Class II Permissive Change Letter

FCC ID: 2AUZX-BVSZUW

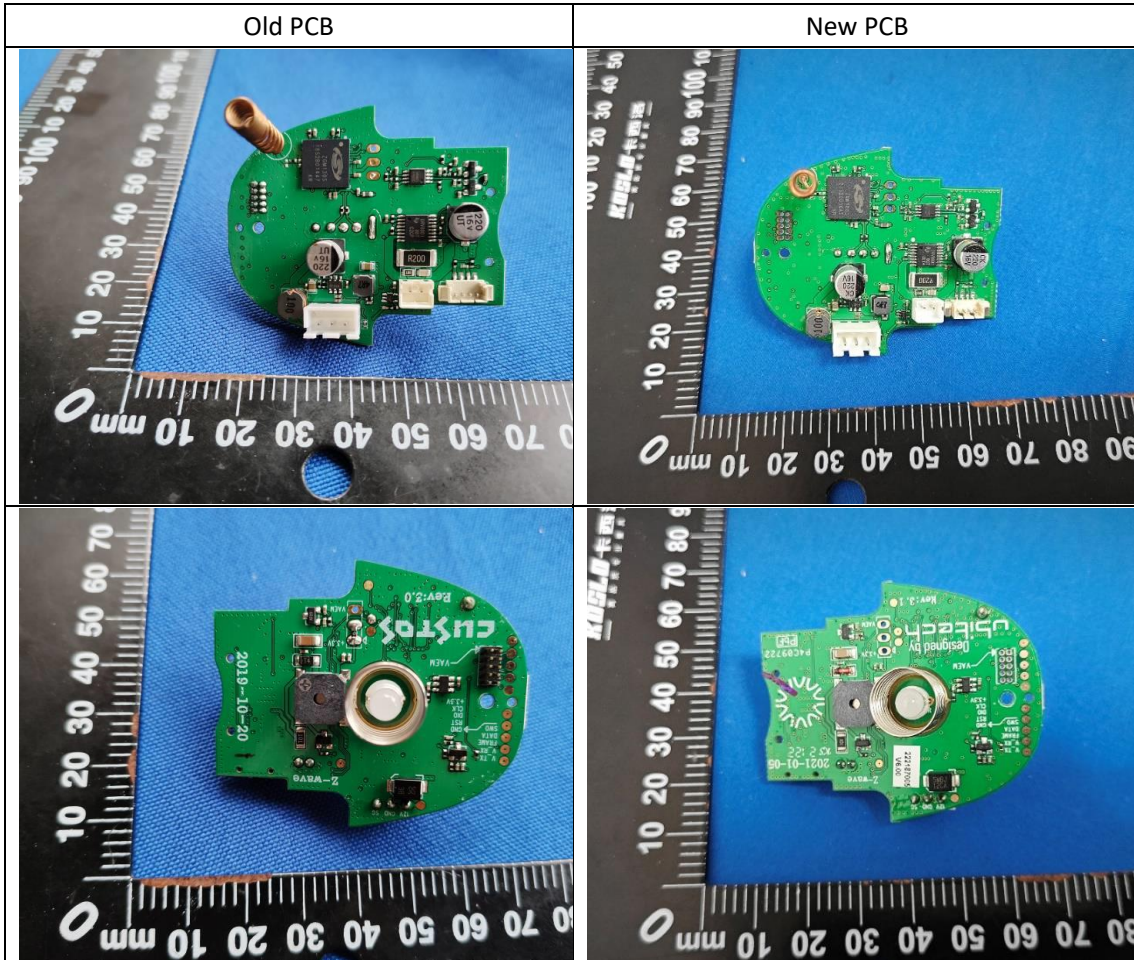
2. Minor PCB Layout change the non-transmitter component replacement.

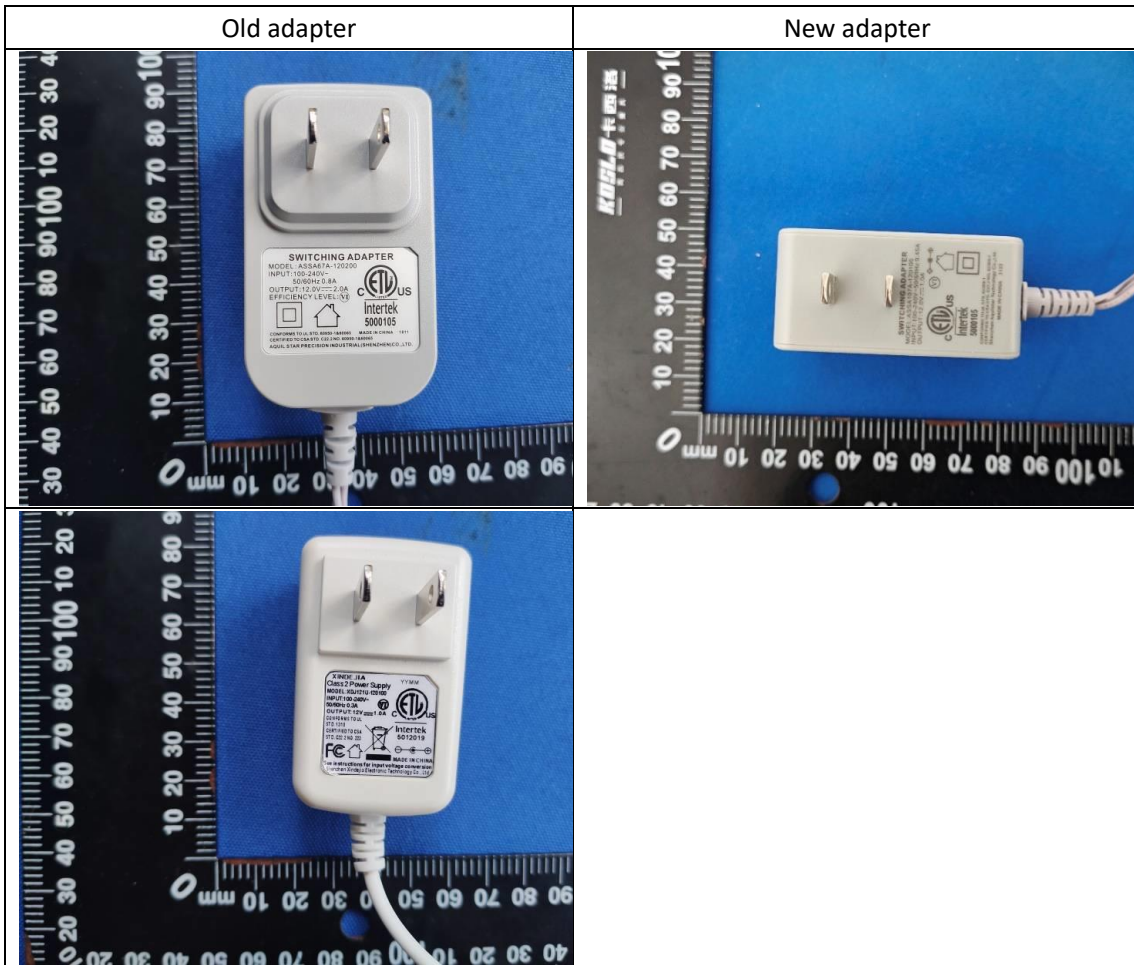
3. Replace the accessories of AC/DC adapter.

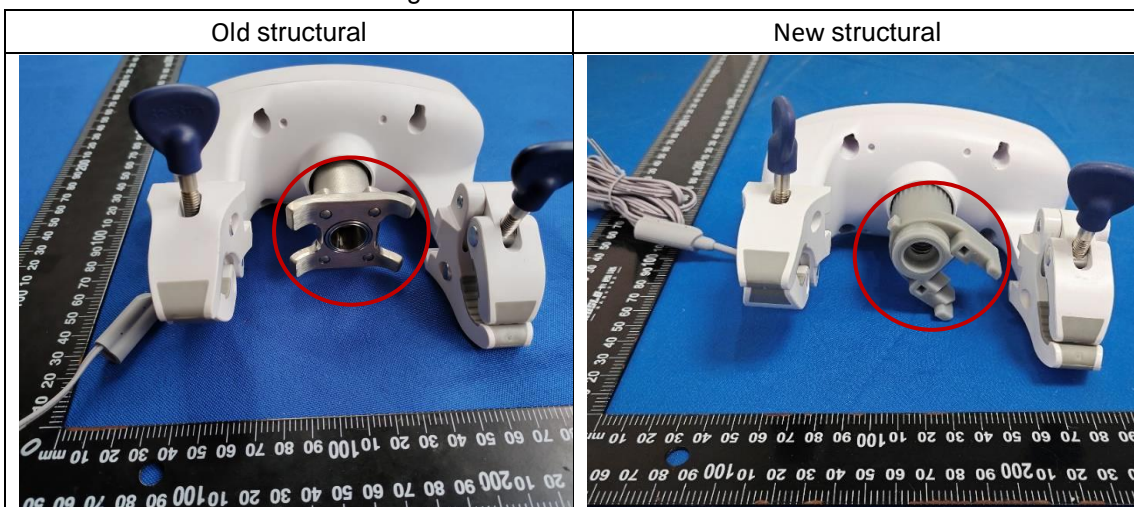
4. local external structural changes.

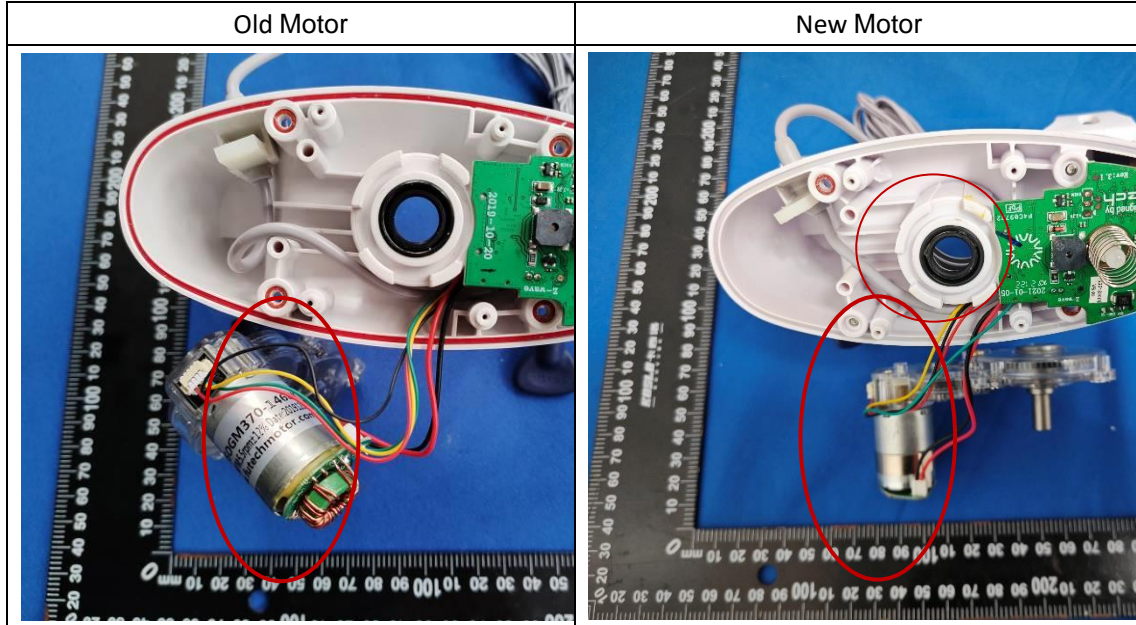
5. Motor equivalent replacement.
